Capacity Procurement Mechanism Soft Offer Cap Straw Proposal: Supplemental Comments by Department of Market Monitoring

September 10, 2019

Figure 1. Estimates of fixed O&M costs of combined cycle resources (\$/kW-year)

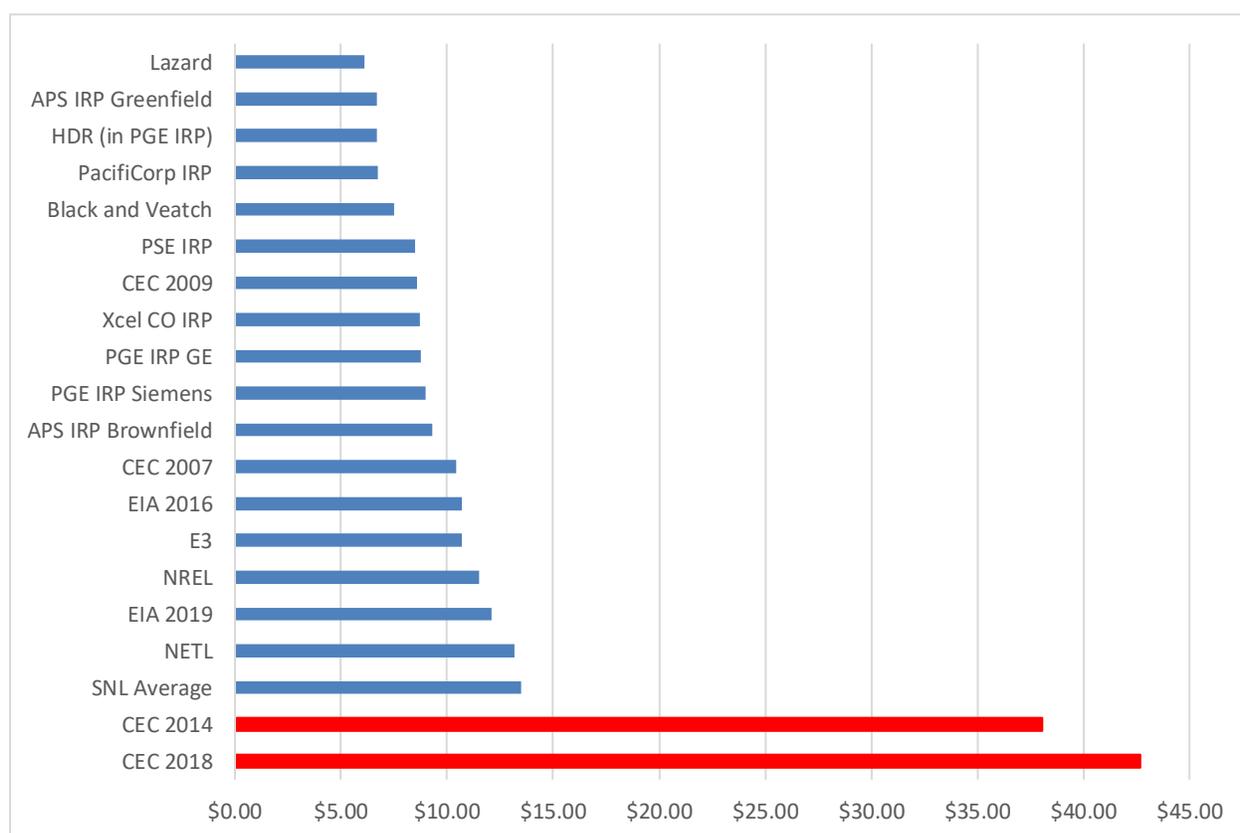
As shown in Figure 1, in comparison with the 18 other sources DMM found for estimates of combined cycle fixed O&M costs, the CEC’s 2014 and 2018 estimates are clearly extreme outliers. Fixed O&M estimates from the CEC data were \$38.06/kW-year for 2014 and \$41.77/kW-year in 2018. However, estimates from other sources range from \$6.12 to \$13.49/kW-year. Thus, the recent CEC estimates are about three times higher than the next highest estimate.

Figure 2. Estimates of Potential Annual Cost and Revenues for Combined Cycle Resources

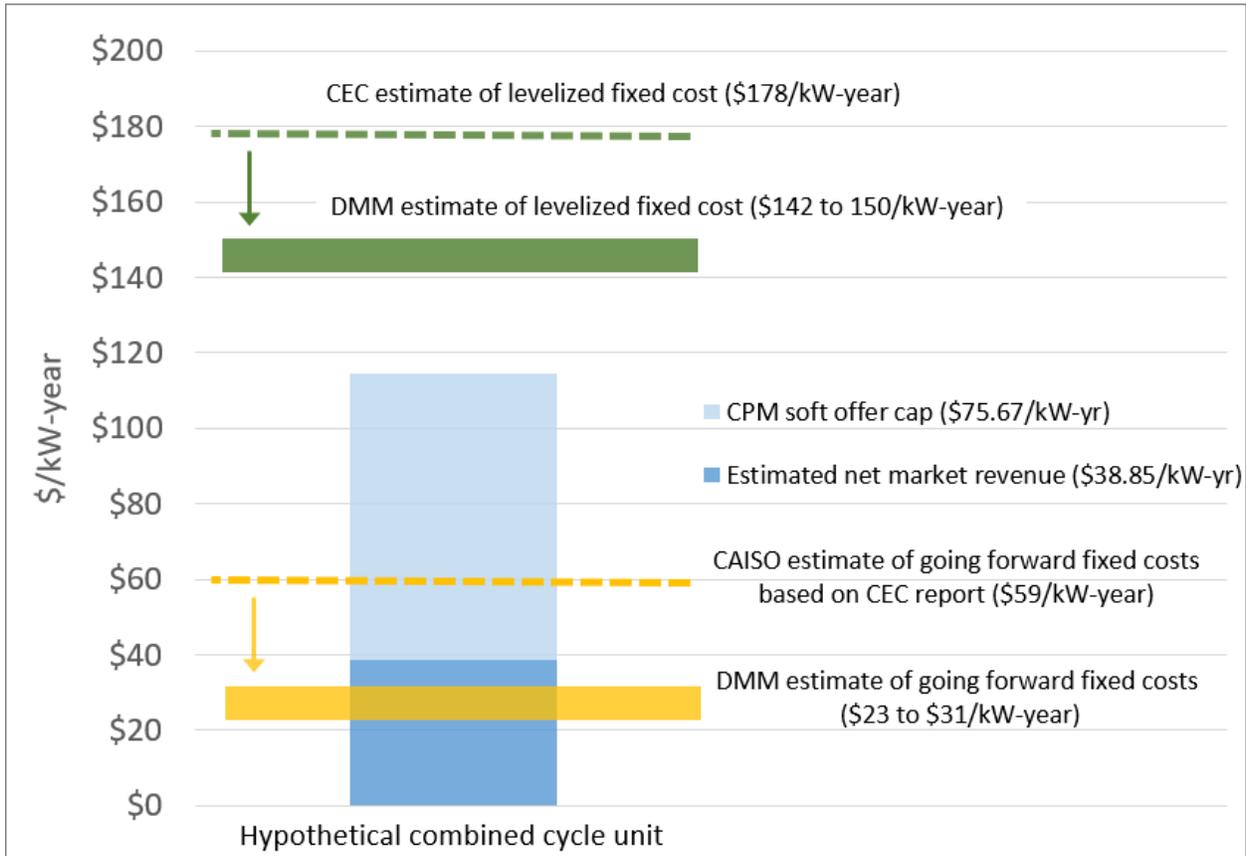
Figure 2 shows the implications of different estimates of fixed O&M costs in terms of the total annualized costs and potential net market revenues of a relatively new combined cycle unit.

- The dark blue bar in Figure 2 is the estimate of net market revenues for a hypothetical combined cycle generator in SP15 provided in DMM's 2018 annual report (\$38.85/kW-year).⁸
- The light blue bar stacked on top of the net market revenue is the ISO's proposed CPM soft offer cap of \$75.67/kW-year.
- The sum of these two numbers (\$114.52/kW-year) is an estimate of the total net annual revenue of a combined cycle resource being compensated at the ISO's proposed CPM soft offer cap.

The dotted yellow line in Figure 2 shows the ISO's current estimate of going forward fixed costs (GFFC) derived from CEC data (\$59/kW-year). The horizontal yellow band in Figure 2 shows the range of going forward fixed cost estimates based on the fixed O&M estimates in Figure 1 (excluding the two recent CEC outliers). The low end of the GFFC range is \$23.25/kW-year and the high end is \$30.62/kW-year. These GFFC estimates include the same values for insurance and ad valorem from the ISO's Straw Proposal, which are in turn based on the 2018 CEC study (\$7.10/kW-year and \$10.03/kW-year, respectively).

The dotted green line in Figure 2 shows the total estimated leveled fixed costs of a new merchant combined cycle unit based on the 2018 CEC report.⁹ These costs include the CEC's fixed O&M estimate of \$41.77/kW-year. The horizontal green band in Figure 2 shows the range of leveled fixed cost estimates for a merchant unit after replacing the CEC fixed O&M value with the high and low fixed O&M estimates from the other sources displayed in Figure 1.
